Access Compliance Report Public Rights-of-Way (Pedestrian Signals)

Main Street: ANTONIO_PKWY Cross Street: N/A Location: SW

ADA ID: SGRK211202130509 Signal Type: One Push Button-Non APS Overall Compliance: No Severity Scores: BTN 1: 10 BTN 2: N/A No BTN: N/A

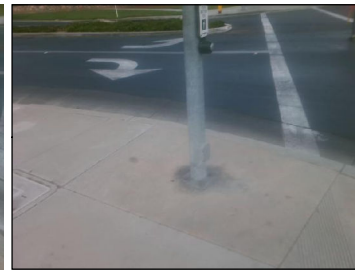
OC Std/PROW: MUTCD 4e.08

Possible Solutions: Replace Signal Push Button With APS Button.
